STAFF RECOMMENDATION
1901 Holly Street
September 16, 2020

Application: New Construction—Infill and Outbuilding; Setback Determination
District: Lockeland Springs-East End Neighborhood Conservation Zoning Overlay
Council District: 06
Base Zoning: R6
Map and Parcel Number: 08314001700
Applicant: Aaron Armstrong, Owner; Jamie Pfeffer and David Brawner, Architects
Project Lead: Sean Alexander, sean.alexander@nashville.gov

SHEET:
SITE PLAN

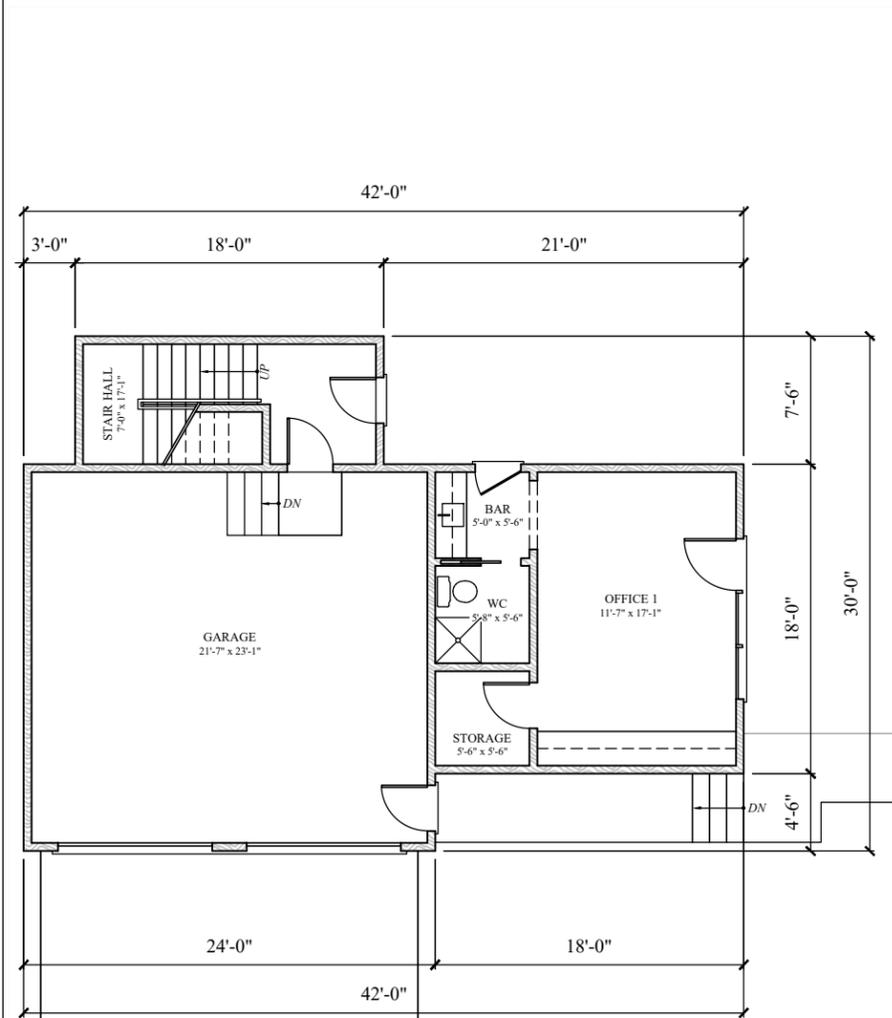
Setback & Rhythm of Spacing: The front edge of the building is proposed to be thirty-three feet (33') from the front of the property, or thirty-nine feet (39') from the curb. This matches the front setback of the previous building. Although several contributing houses on the north side of this block were lost as a result of the March 3rd tornado, three contributing houses remain. Staff finds that matching the street setback of the remaining historic houses is compatible with the surviving context.

The building's side setbacks will be ten feet (10') on the left side and eight feet (8') on the right. The separation between the proposed new building at 1901 and the house to the right will be twenty-eight feet (28'), because there will be a driveway along the left side of the house at 1903 Holly Street. Staff finds that the side setbacks are consistent with the rhythm of spacing in the historic context.

1. The finished floor height shall be consistent with the finished floor heights of the adjacent historic houses, to be verified by MHZC staff in the field;
2. The front setback shall be consistent with the setbacks of the adjacent historic houses, to be verified by MHZC staff in the field;
3. The majority of the first story windows on the left side should be as tall or taller than those of the upperstory; and
4. The window and door selections shall be approved by MHZC Staff;
5. The roof color and brick and stone selections shall be approved by MHZC Staff; and
6. The utility connections and HVAC units shall be located behind the midpoint of the building on a non-street facing façade.

holly street elevation

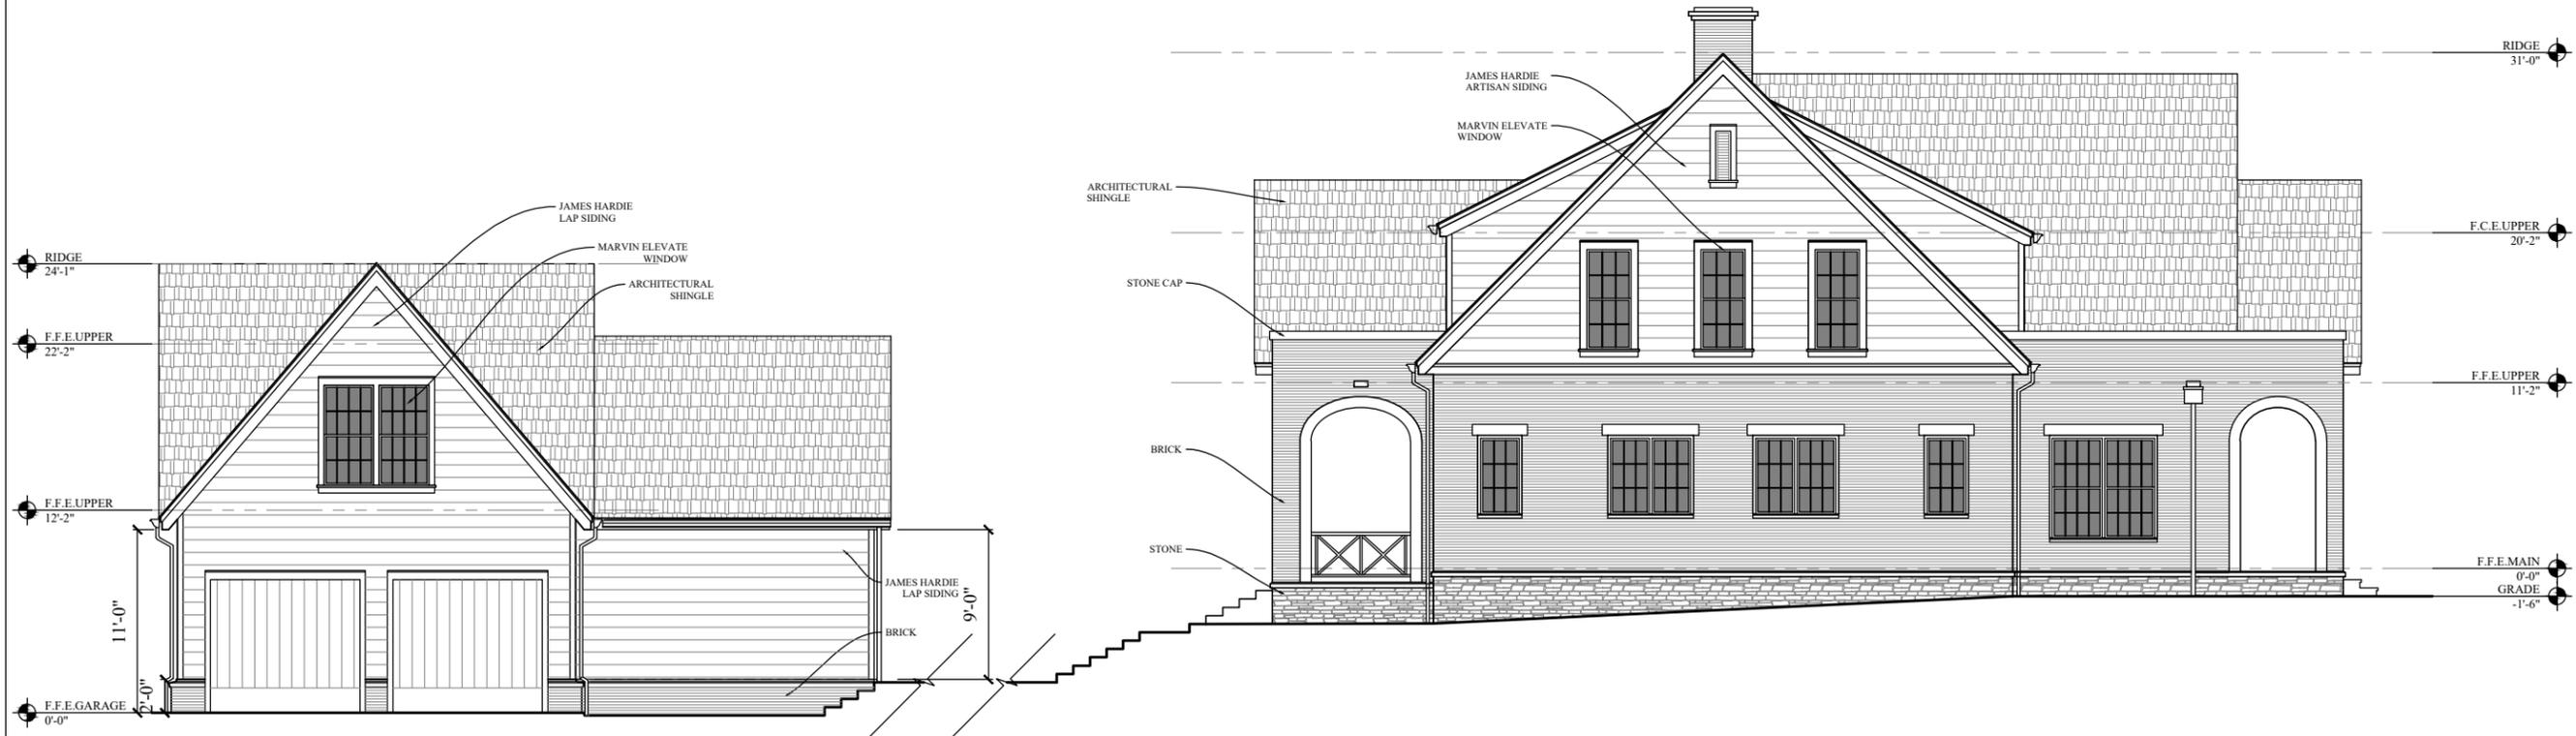
There will be a small shed-roofed dormer on the front of the house, and a larger shed-roofed dormer on the rear. The pitch of these dormers is 6/12, which is a common roof form for dormers. The front dormer will not be stepped back from where the primary roof bears on the first-story wall, it will be stepped back from the actual front wall of the house which is twelve feet (12') further toward the front of the house.

Proportion and Rhythm of Openings: There will be three bays on the front façade of the house on the first story, with three doors on the left bay inside the front porch, a door and sidelights in the center bay, and a set of three double-hung windows on the right. While not symmetrical, this façade is balanced and is compatible with the rhythms of nearby houses.

east elevation

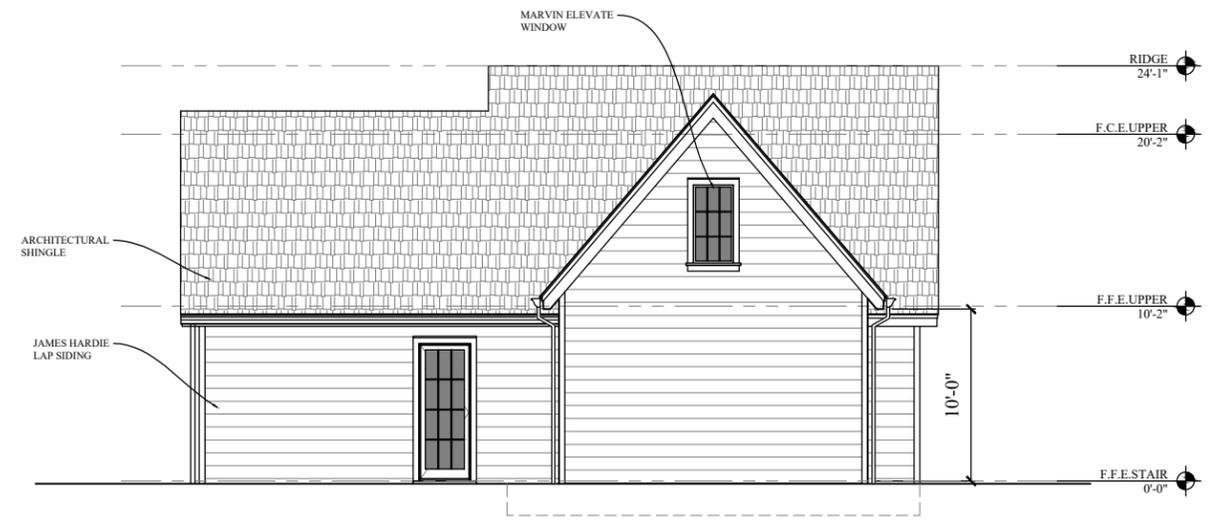
The side elevations will have multiple windows on each level, evenly spaced on the façades. The upperstory windows on the left side façade, facing South 19th Street, are taller than the majority of the first story, whereas historically the windows on a first story were taller than upperstory windows. The front, rights side, and rear all have appropriate window proportions.

With a condition that a majority of the first story windows shall be at least as tall as those of the upperstory on the left side, staff finds that the proposal will be compatible with the surrounding context and that the project will meet section II.B.7 of the design guidelines.
